CITY OF ALBUQUERQUE

RE: **Whataburger
Grading and Drainage Plan
Engineer's Stamp Date 2-18-2015 (File: K10-D001B)**

RE: **Whataburger
Grading Plan
Engineer's Stamp Date 2-18-2015 (File: K10-D001B)**

WHATABURGER
COORS AND CENTRAL
GRADING AND
DRAINAGE PLAN

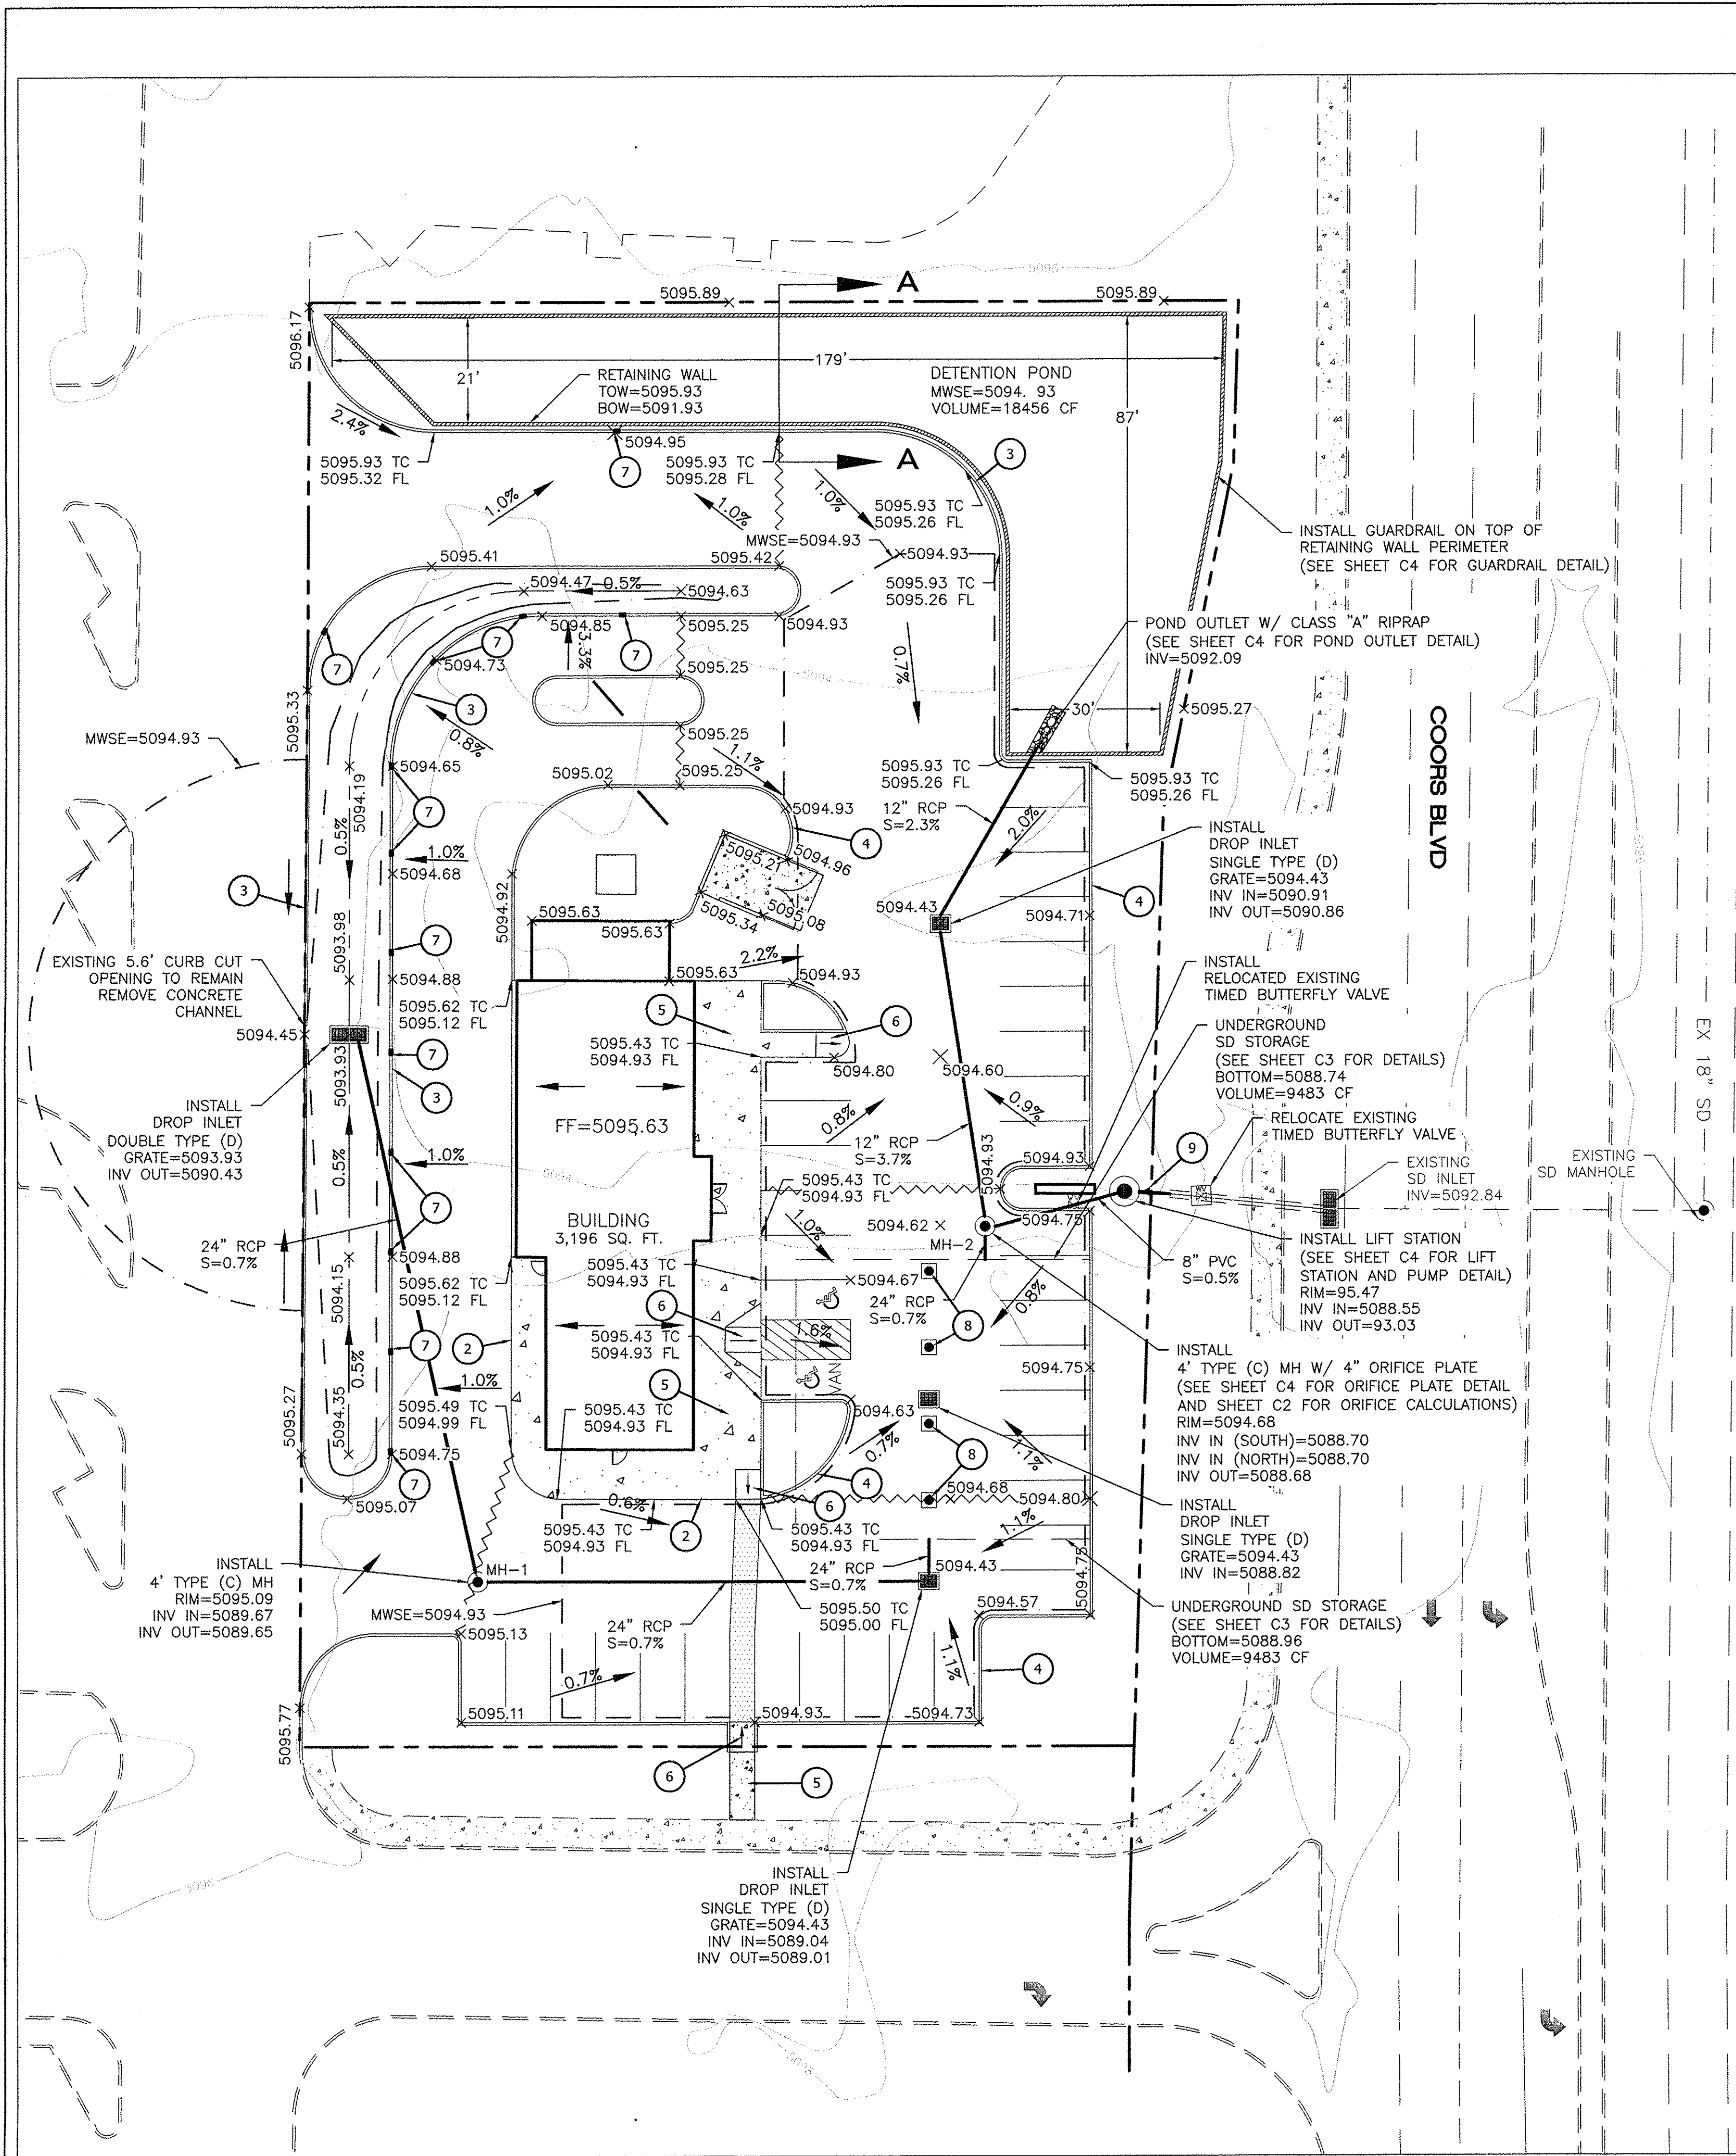
- 2) On the plan view for the "Grading and Drainage Plan", label all of the different detention volumes that correspond to the "Proposed Conditions" discussion which include the 0.43 ac-ft detention pond, the 0.16 ac-ft surface pond, and the underground storage of 0.22 ac-ft. Show the underground storage system area on the plan view for the "Grading and Drainage Plan", and label the connections from the new 24-inch storm drain to this underground storage system.

- 3) There is a Section A-A on the "Grading and Drainage Plan" which shows pond elevations within the detention pond in the north area of the site. Provide more spot elevations within this area at the corners of the pond to ensure that there will be enough volume provided for the detention pond.

- 5) How is storm drainage getting to the Double-D inlet on the west side of the site? Provide capacity calculations for the 5.6-foot wide curb cut that is accepting the off-site flow from the west and adjust as necessary.

- 6) Provide capacity calculations for all of the curb cuts shown on the plan.

- 8) It is not clear if the subject site is accepting off-site flows from the site or how the site to the north will be impacted. Include discussion of off-site flows from the site to the north to ensure that grading of the Whataburger site does not adversely impact this site.
